# Work Order ID 107737

Item ID: D407-667-105

Item Name: Fwd Crosstube

DRAWING NO. D407-667-145	TITLE CROSSTUBE ASS'Y (407 HIGH FWD)	REV. C	<b>DART AEROSPACE LTD ENGINEERING ORDER</b>		D.E.O. NO. D407-667-145-C-1	SHEET NO. SHEET 1 OF 1	SCALE NTS
DRAWN 40	CHECKED ASS	MFG. APPR. 18	APPROVED WD		DE APPR. H		
DATE 11.07.15	DATE 11.07.22	DATE 11.07.22	DATE 11/07/22		DATE 11.07.21

**DETAIL P**  
BONDING STRAP INSTALLATION 2 PL

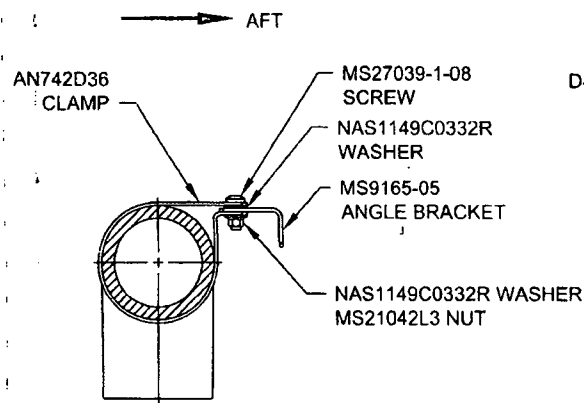
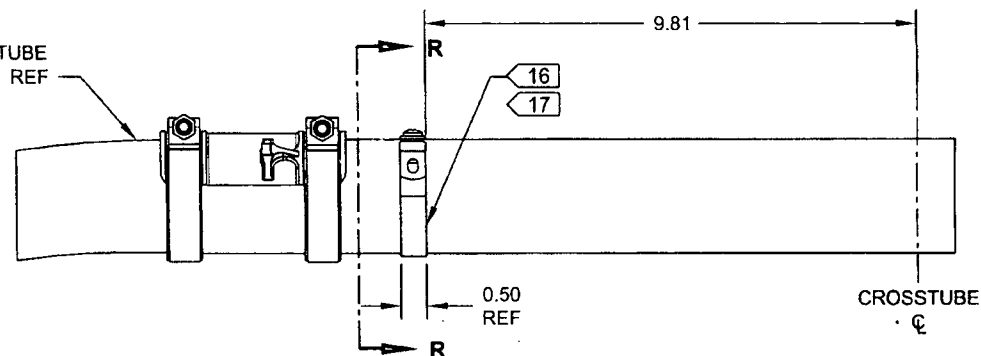
ADD ELECTRICAL GROUNDING STRAP

ITEM	QTY -145	PART NUMBER	DESCRIPTION
1	X	D407-667-145	CROSSTUBE ASSEMBLY (407 HIGH FWD)
⚡			
10	2	AN742D36	CLAMP
11	2	MS9165-05	ANGLE BRACKET
12	2	MS21042L3	NUT (OR MS21042-3)
13	2	MS27039-1-08	SCREW
14	4	NAS1149C0332R	WASHER (OR AN960C10L)

— ADD
